# Technical Service Bulletin

SUBJECT: <b>SEAT BELT FRAYED FROM BEING CAUGHT UNDER SEAT RECLINING ADJUSTING LEVER</b>			No: <b>TSB-18-52A-001</b>
			DATE: <b>April 2018</b>
			MODEL: <b>See below</b>
CIRCULATE TO:	<input type="checkbox"/> GENERAL MANAGER	<input checked="" type="checkbox"/> PARTS MANAGER	<input checked="" type="checkbox"/> TECHNICIAN
<input checked="" type="checkbox"/> SERVICE ADVISOR	<input checked="" type="checkbox"/> SERVICE MANAGER	<input checked="" type="checkbox"/> WARRANTY PROCESSOR	<input type="checkbox"/> SALES MANAGER

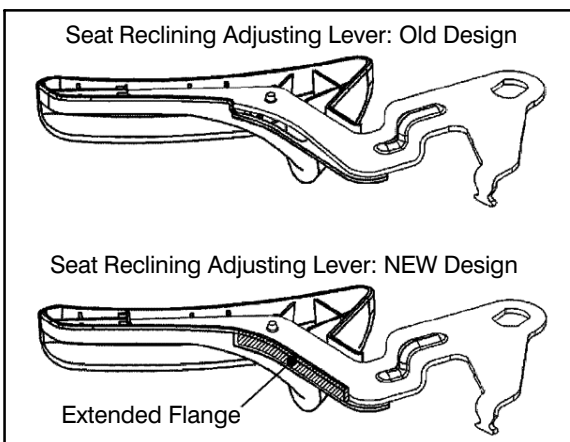
The shape of the seat reclining adjusting lever has been modified to prevent fraying of the seat belt should it get caught under the lever.

**NOTE:** The new part has an extended flange. This design ensures the seat belt will not rub against the edge of the lever or the tip of the tapping screw.

2. Confirm the replacement seat reclining adjusting lever is the new countermeasure part.

3. Remove the tapping screw, then pull out the seat lever to the front of the vehicle and remove it.

4. Install the plastic cover of the new seat reclining adjusting lever onto the metal lever as shown.

5. Tighten the tapping screw.
